UNITED STATES
DEPARTMENT OF THE INTERIOR
BUREAU OF LAND MANAGEMENT

SUNDRY NOTICES AND REPORTS ON WELLS
*Do not use this form for proposals to drill or to re-enter an
abandoned well. Use form 3160-3 (APD) for such proposals.*

OXY USA WTP LP respectfully requests to temporarily abandon this well. It is currently being evaluated for possible Yeso recompleat.

OXY USA WTP LP
Old Ranch Knoll 8 Federal Com. #6
API No. 30-015-32295

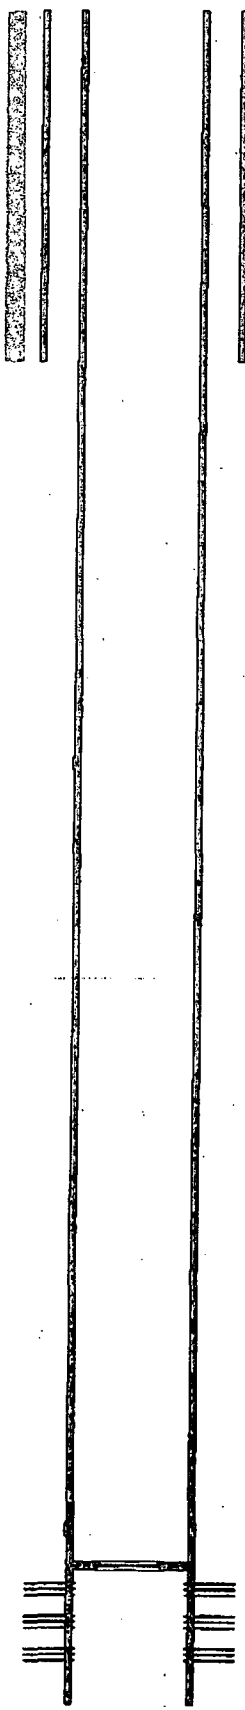
1. RIH & set CIBP @ +/-8193'
2. Notify BLM/NMOCD of casing integrity test 24hrs in advance.
3. RU pump truck, circulate well with treated water, pressure test casing to 500# for 30 min.

- a. A bridge plug or packer must be installed as close to 50 feet above any open perforations or open hole as possible. If a cement plug is used, the top of the cement must be verified by tagging. CIBP must be capped with minimum 25 sacks cement, **placed with tubing**.

- b. The wellbore must be filled with corrosion inhibited fluid and pressure tested to 500 psi. The casing shall be capable of holding this pressure for at least 30 minutes. Any leak-off will be evaluated.
